CONSTRUCTION PLANS

ADVENTHEALTH PARKER EXPANSION

DRAWING TITLE: **COVER SHEET**

C241

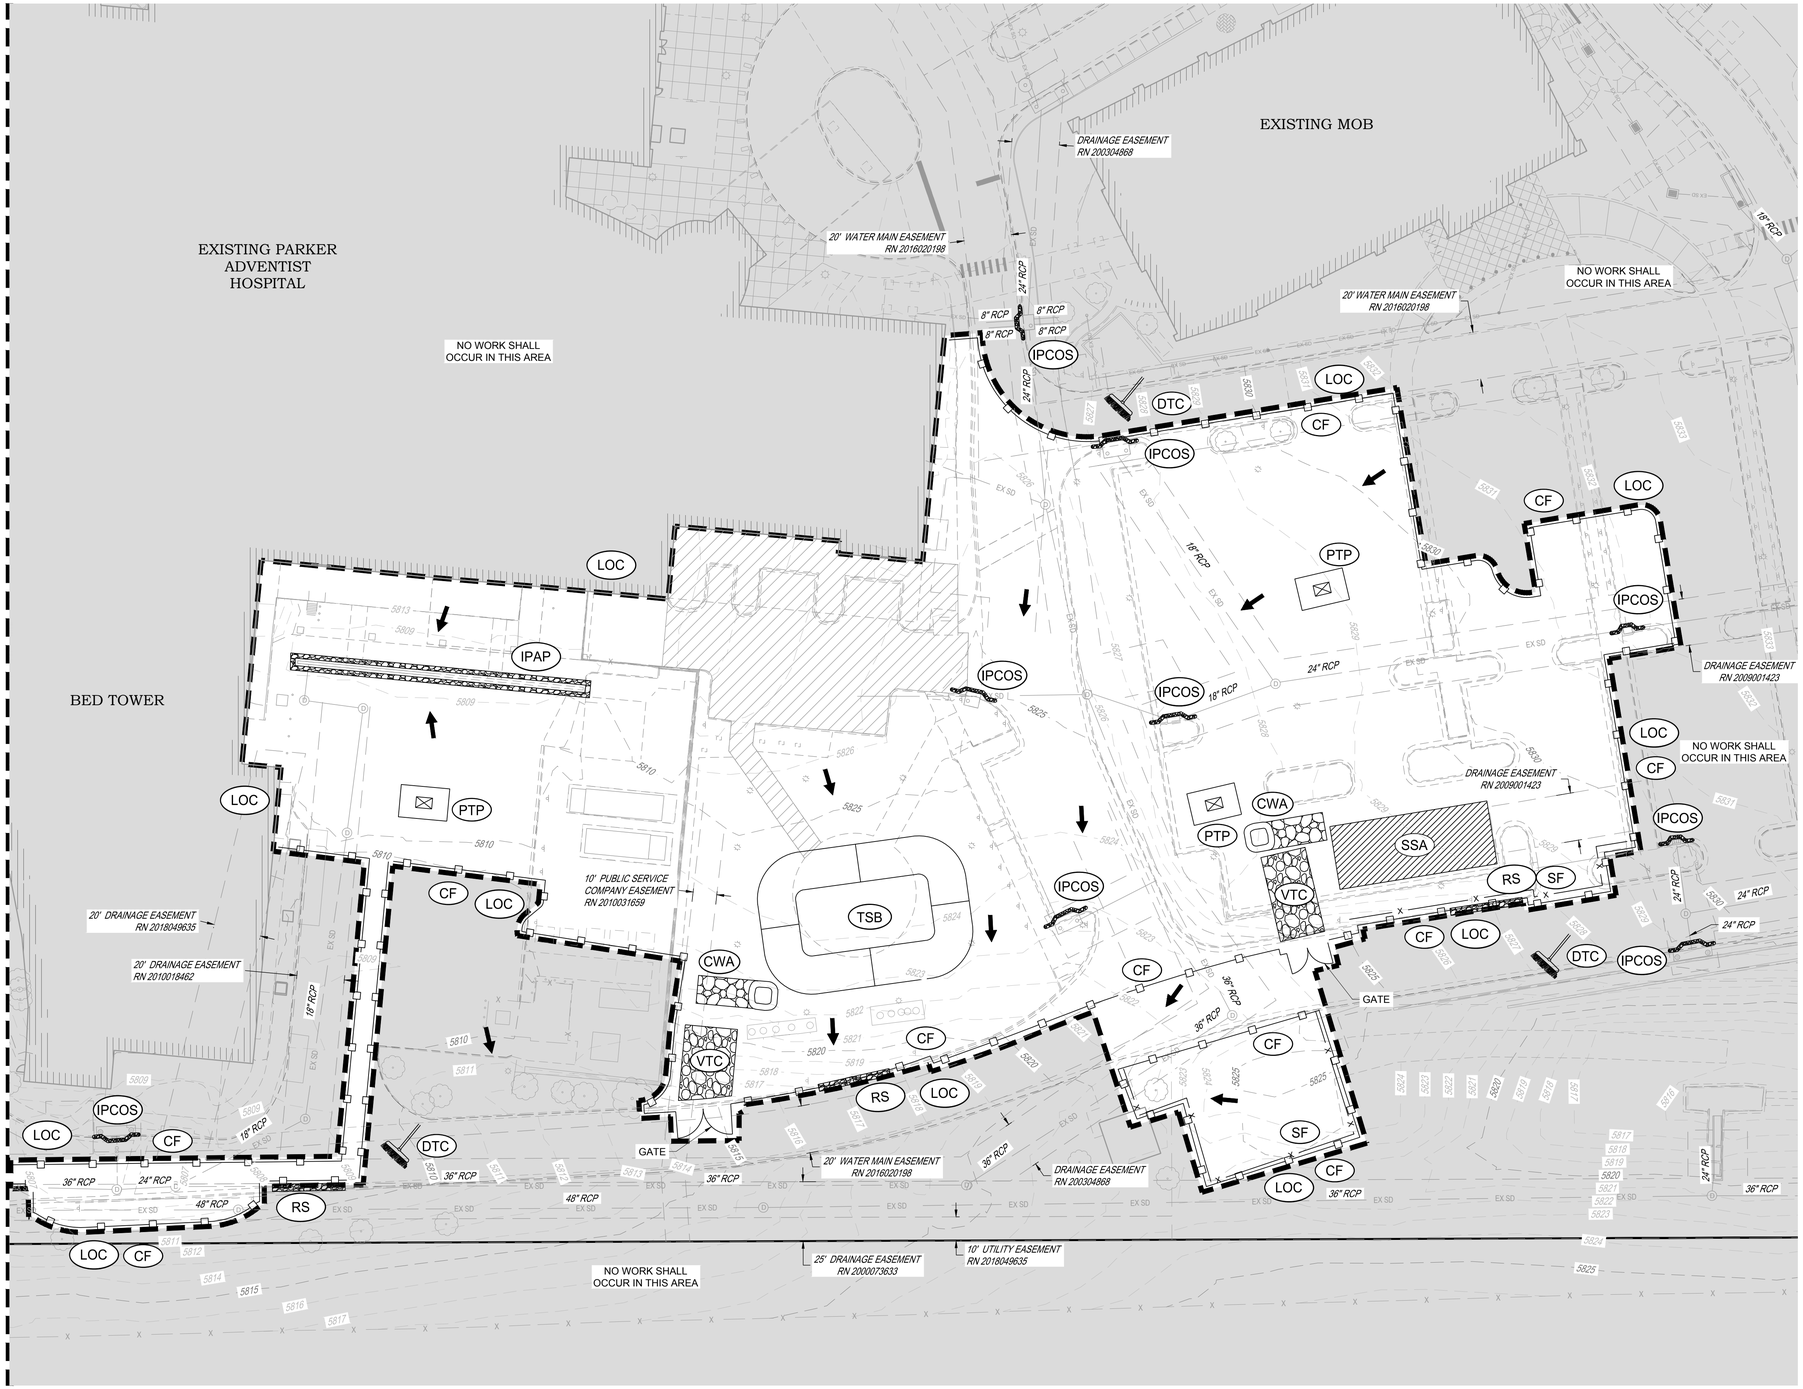
Please include Key Map

DRAWING NUMBER:
C243

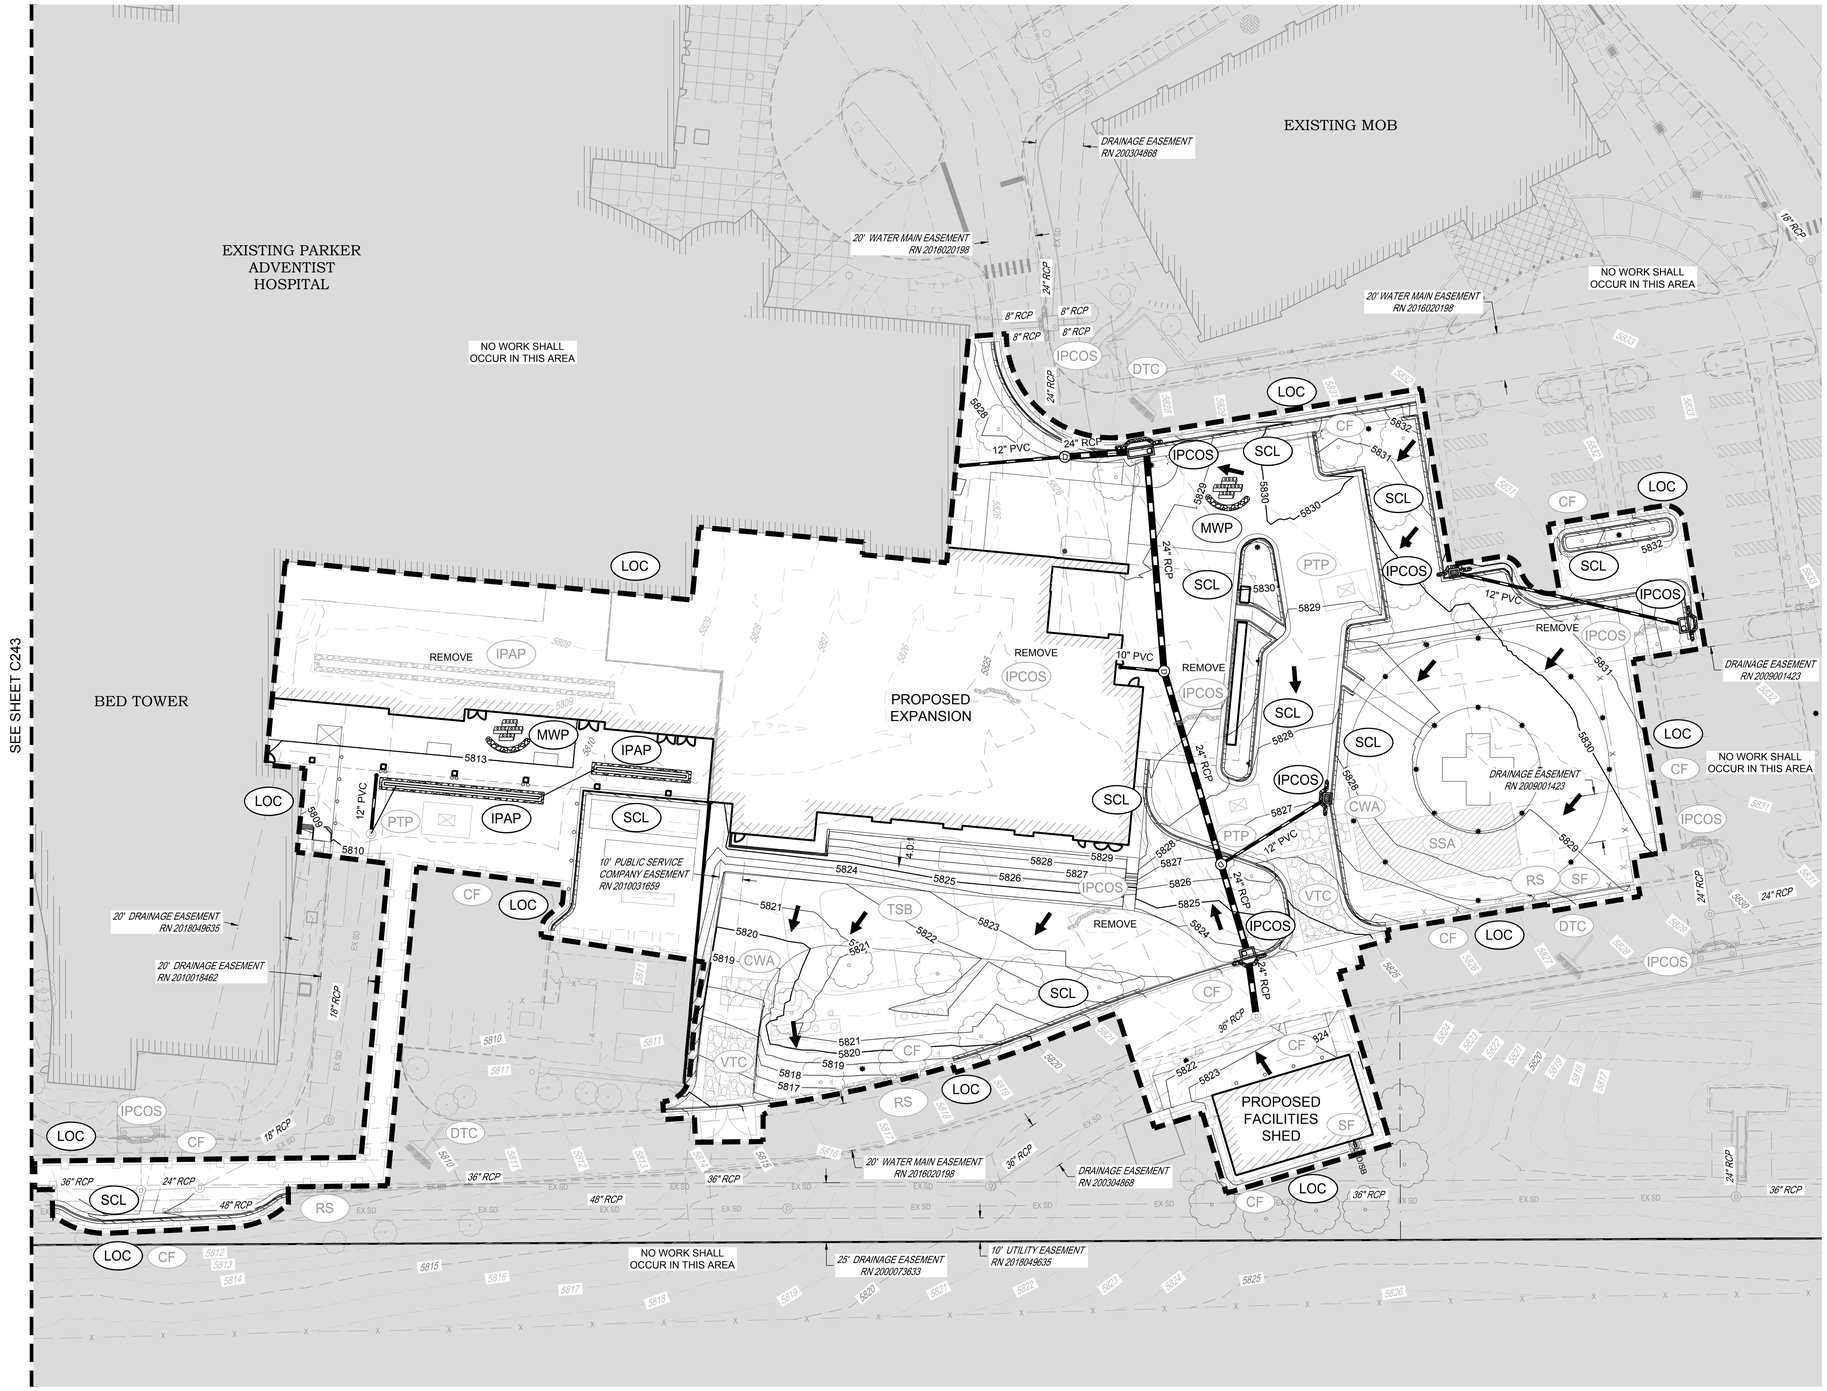
Please include Key Map

DRAWING NUMBER:
C245

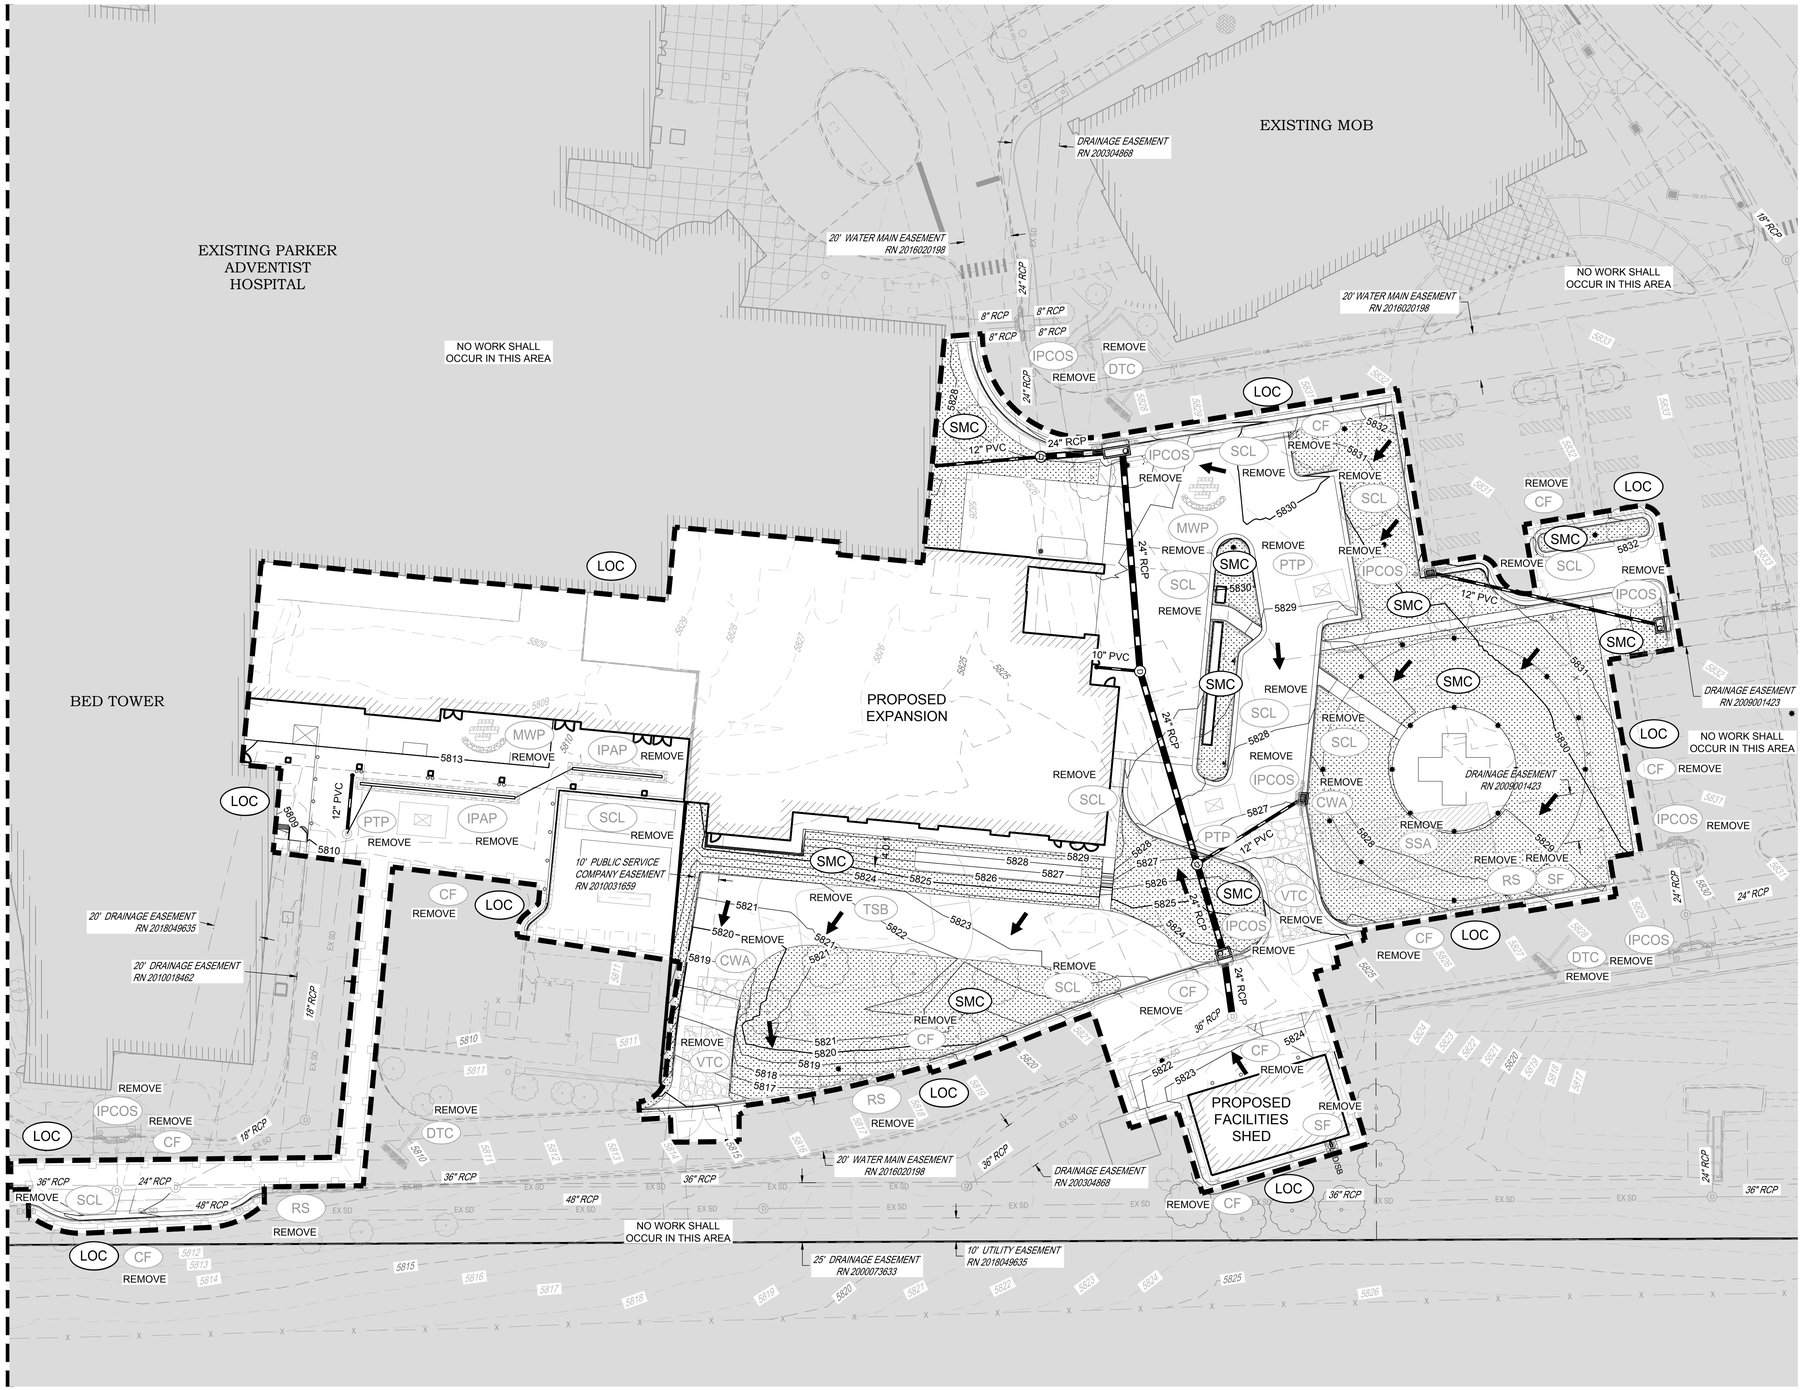
Please include Key Map

STORM LINE A PLAN

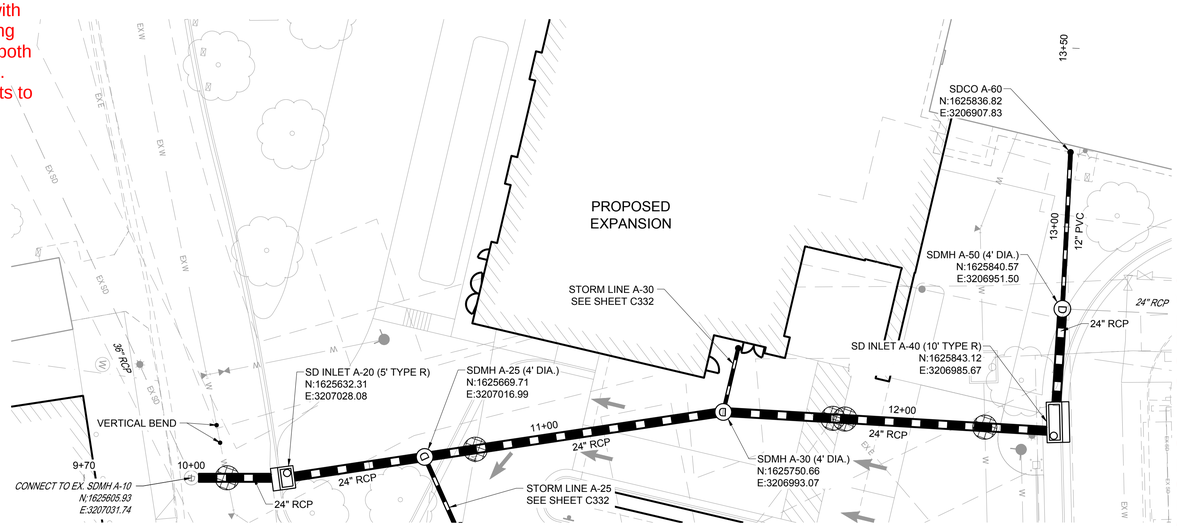
The drainage report that was submitted with the Site Plan Application states the existing orifice restrictor plate will be replaced on both the South Pond B and Southwest Pond A. Provide details for proposed improvements to the ponds and location with labels to said ponds on a map within the construction plans.

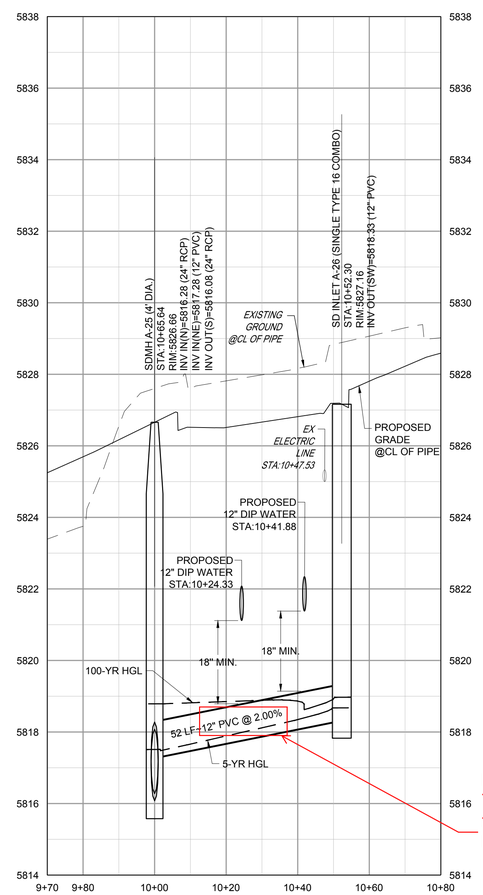
Please see Table 6.3 of the SDECM. Laterals from inlets must be min 18" RCP.

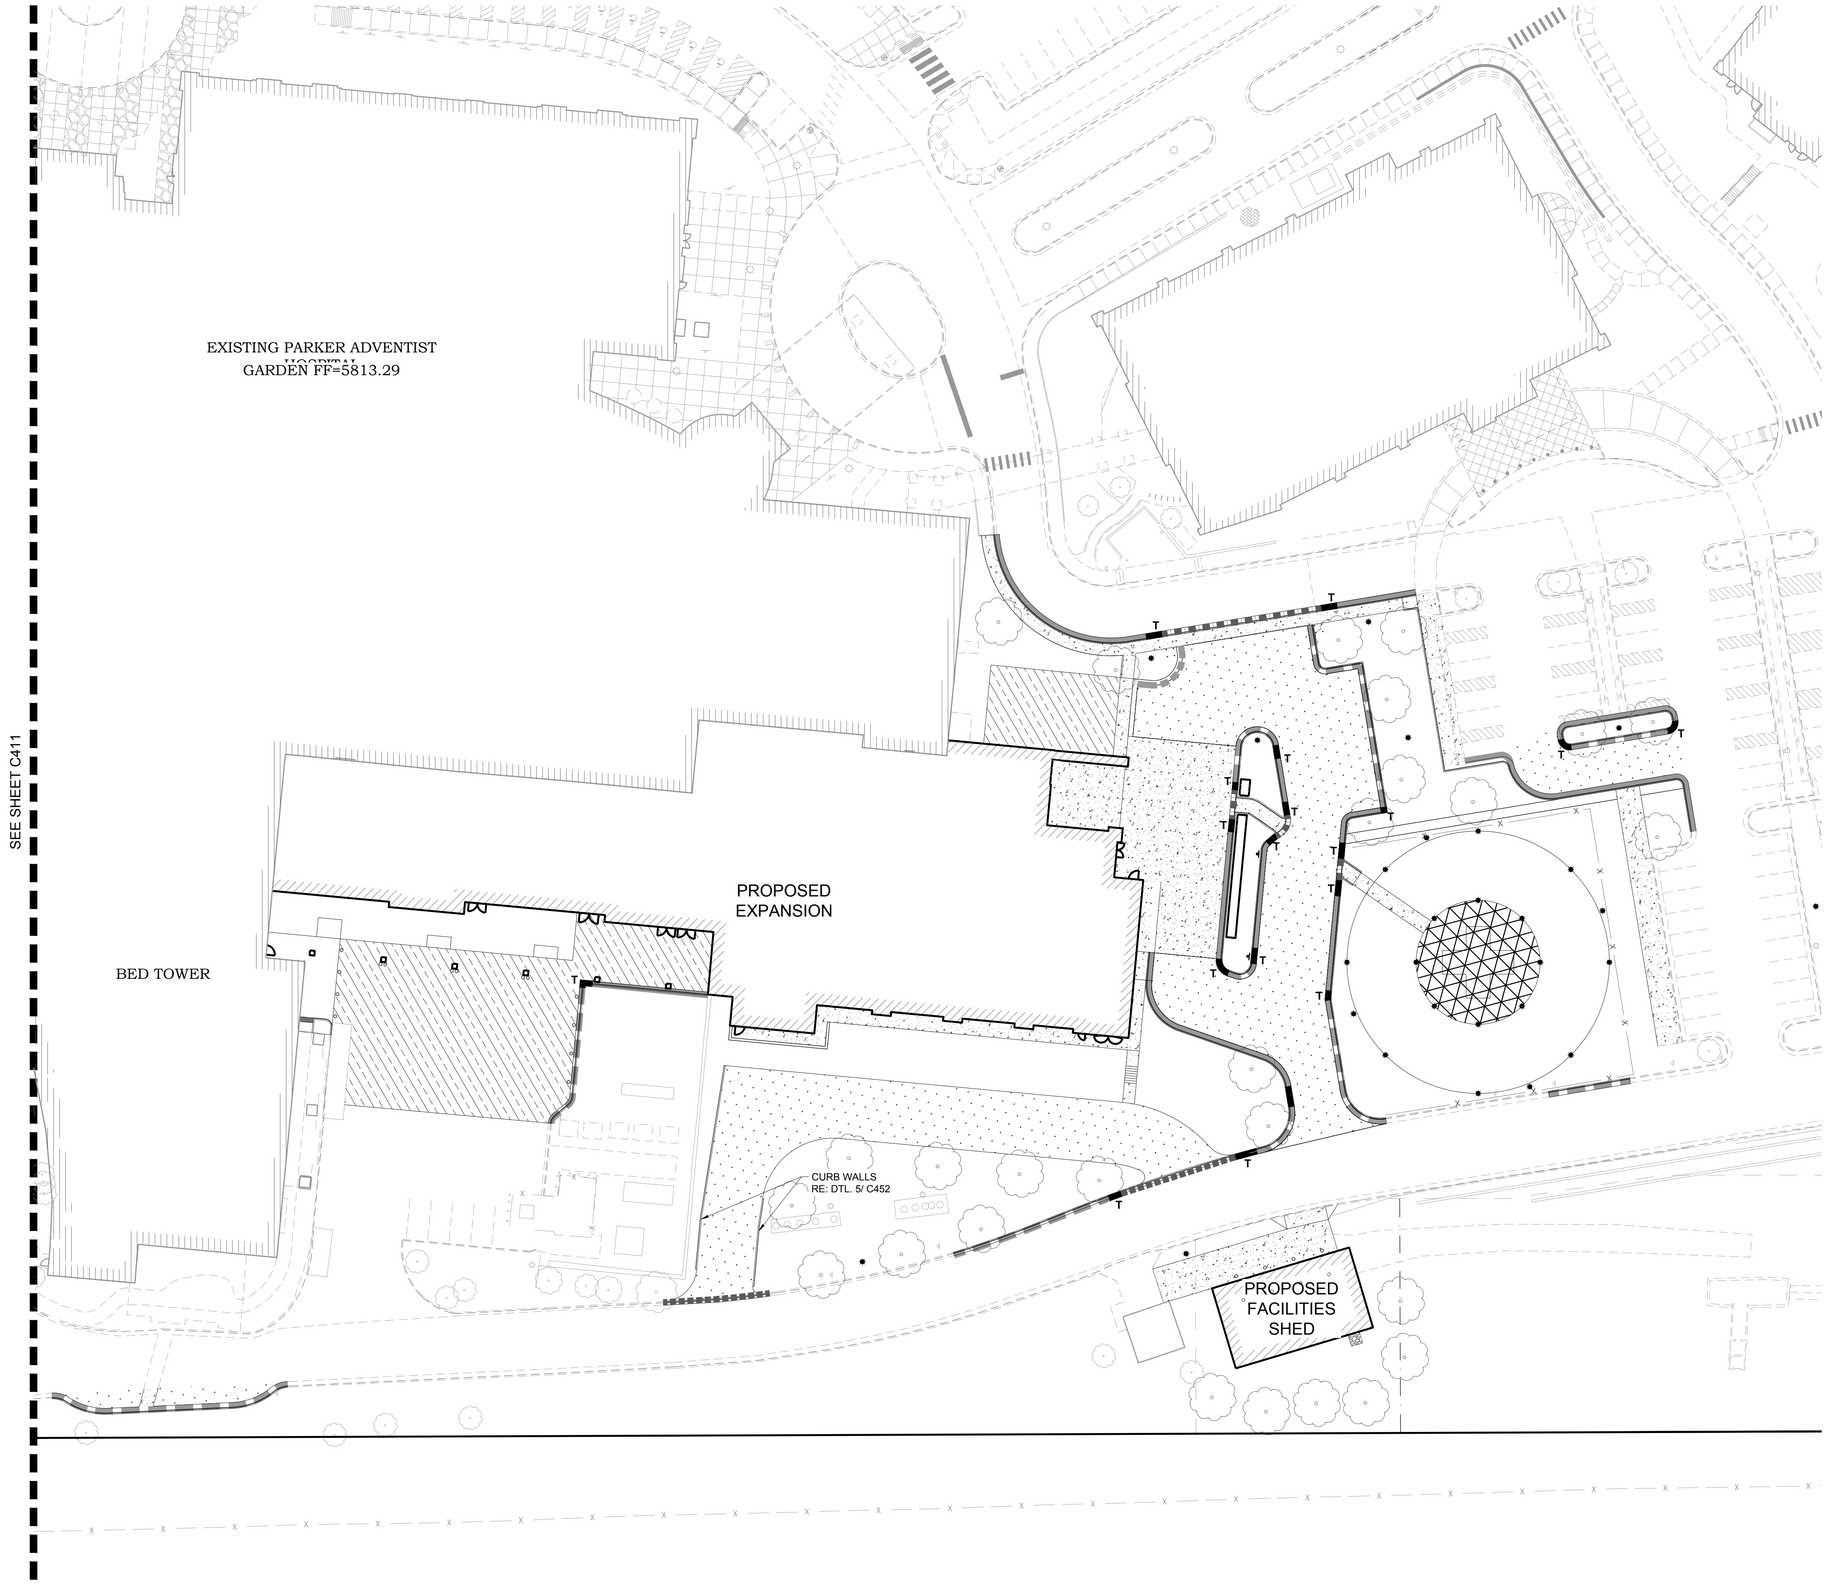
Please include Key Map
